FIELD CHANGE ORDER

NO. 17-011

RCSL: 44-RT 1196

MANUFACTURING EFFECTUATION DCC 702/2,5 and upwards	EQUIPMENT AFFECTED RC 3600/6000 RC 3688/DCC 701/DCC 702 Cartridge Disc Drive Channel
NOTE

DCA 701 09

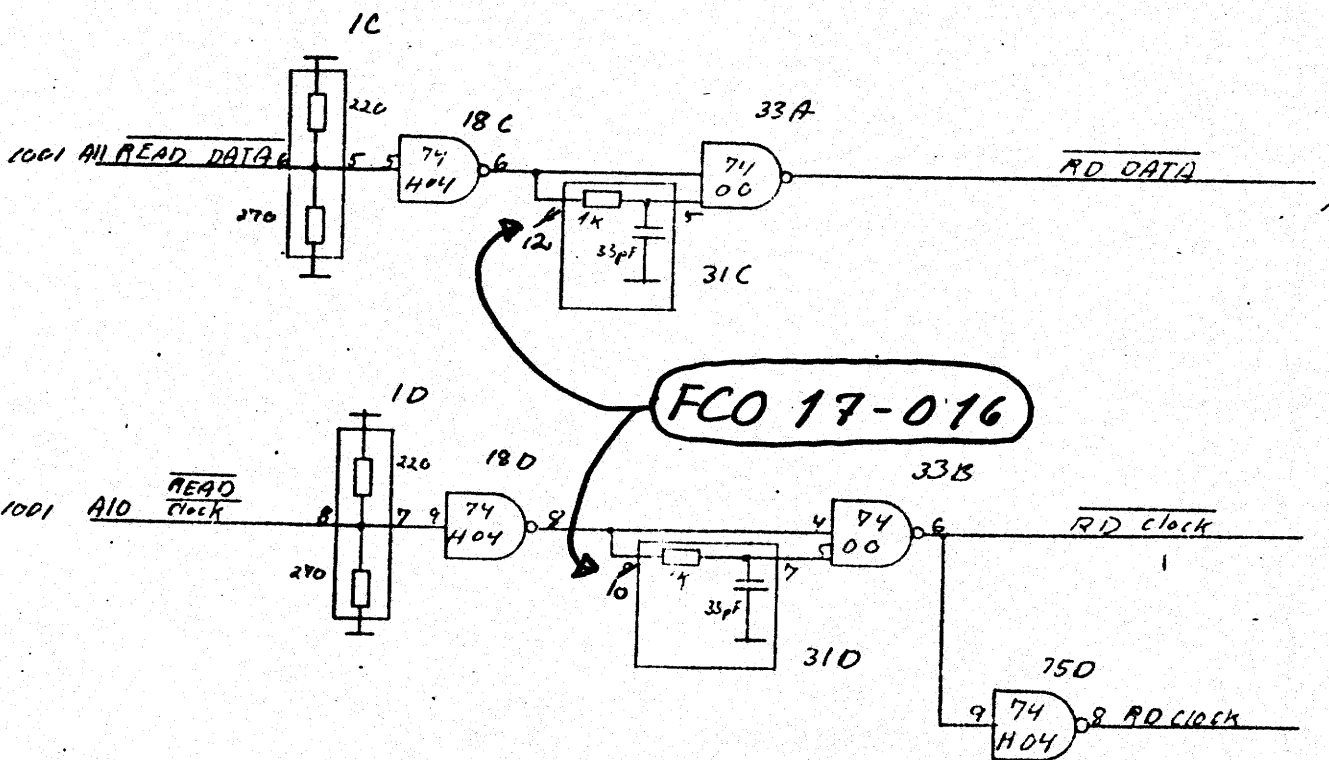
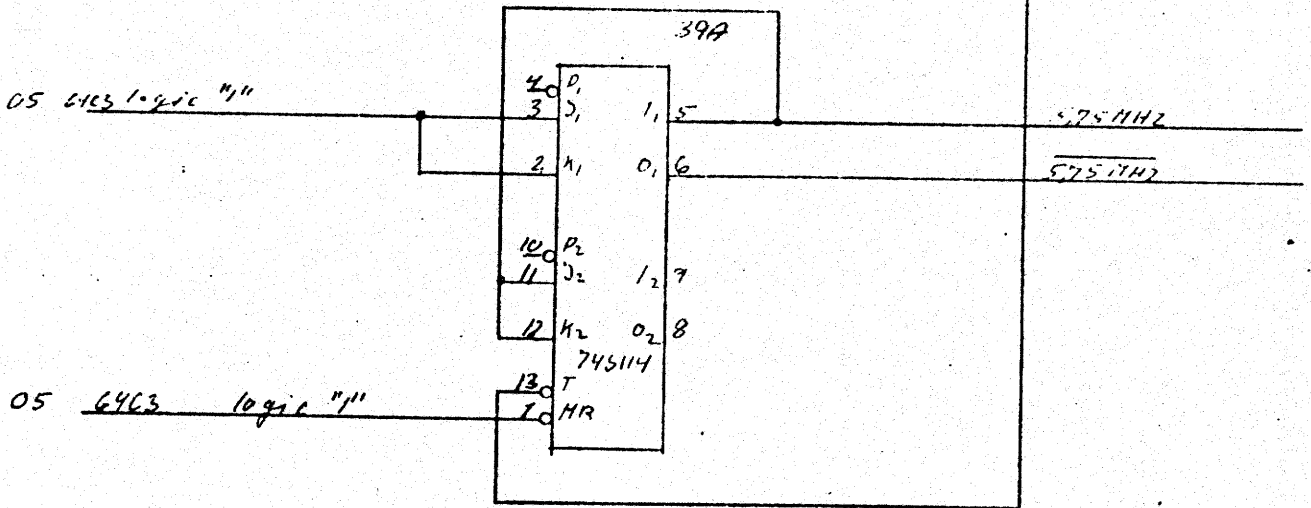
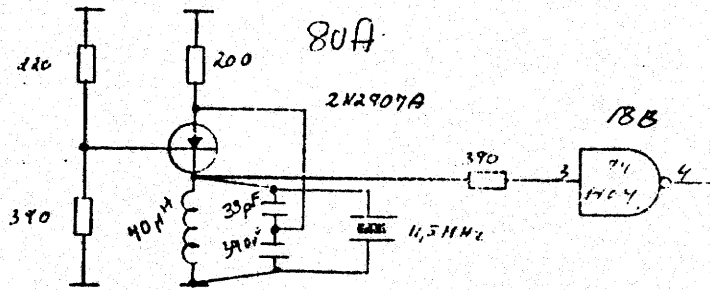
Wrong wire connections on DCA 701.
 The filters on the READ DATA and the READ CLOCK are not connected, and this may cause data errors.

- Execute the wiring changes as shown on the enclosed Hardoc formula.
- Code the FCO-Label 17-016

F 7 CIRCUIT DIAGRAM FOR 3029 PSU

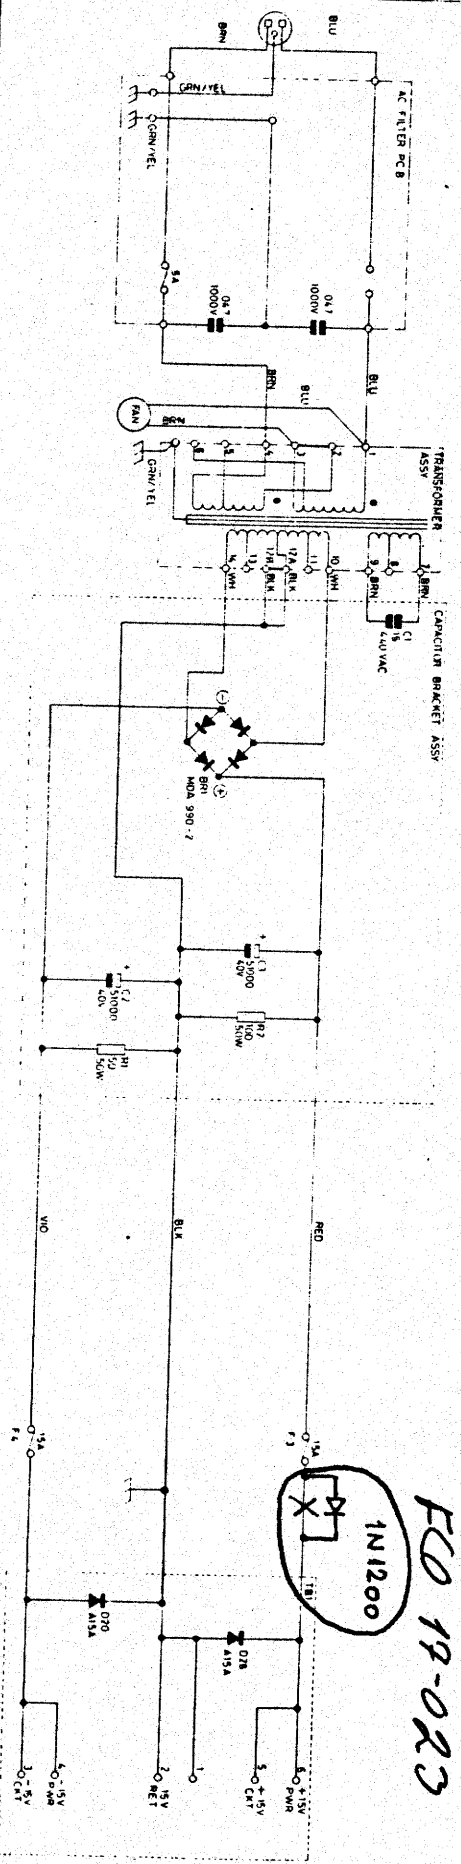
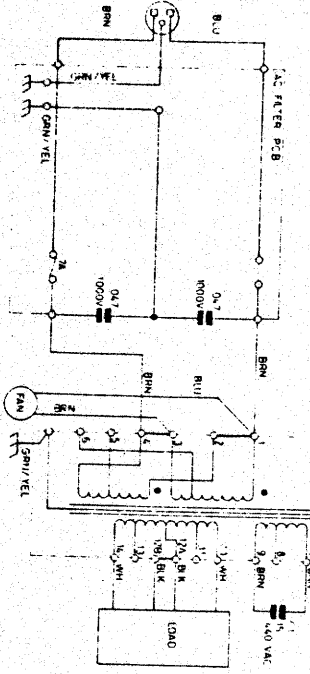
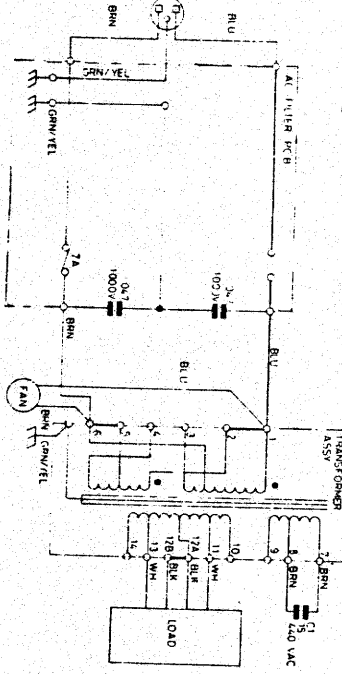
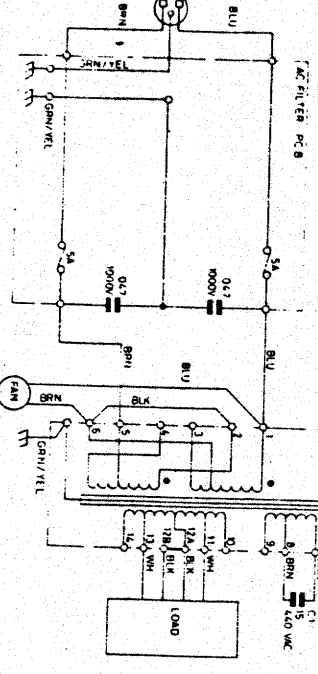
REASON FOR CHANGE
Too high voltage on the disc drive power supply causes long delays on start up of the disc drive, and in worst cases the drive will not start up at all.

DESCRIPTION OF CHANGE
A diode is mounted in series with the +15V in the power supply.
1) disconnect power.
2) open back cover
3) place the diode at the fuse, so it is connected in serial with the +15V fuse.
4) place a FCO-Label on the power supply and code it 17-023.
